MACQUARIE POINT ADDENDUM

Comments on Neil Shephard and Goss Orbit Solutions reports to TPC.

7 July 2025

Saul's montage from Tasman Hwy indicates to the contrary:

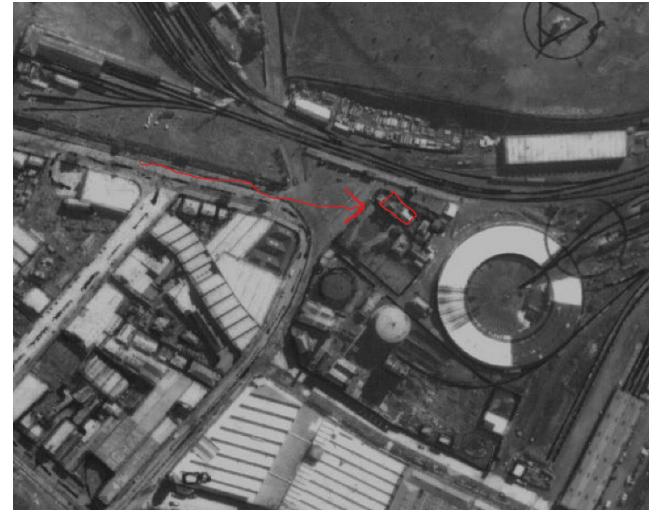
Saul's Tasman Hwy montage demonstrates there is little if any "mitigation" of bulk and scale, no matter the extent of "significant curtilage".

The "perspective" in the montage shows that the "curved façade" and "domed roof" do not diminish the visual impact.

From a distance the form of the building will become more like an elevation particularly from the eastern shore.

Part Fig 17: 1946 photo

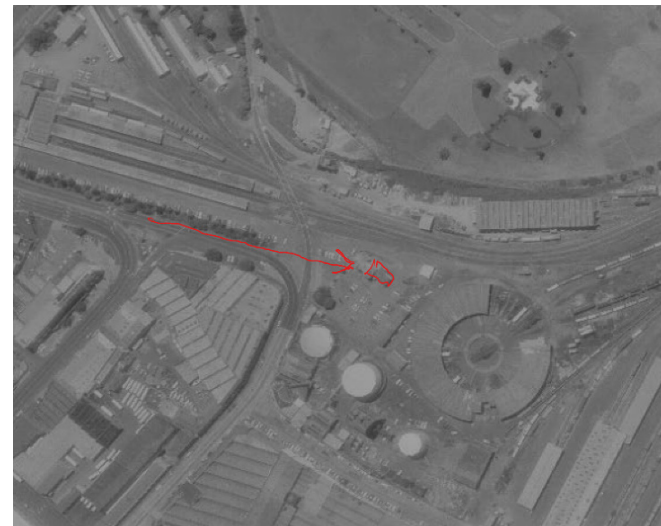
The views below (from Purcell GJM) do NOT indicate a significant extent of buildings forming a “backdrop” to REB that in anyway equate to the proposed view from Brooker Avenue:
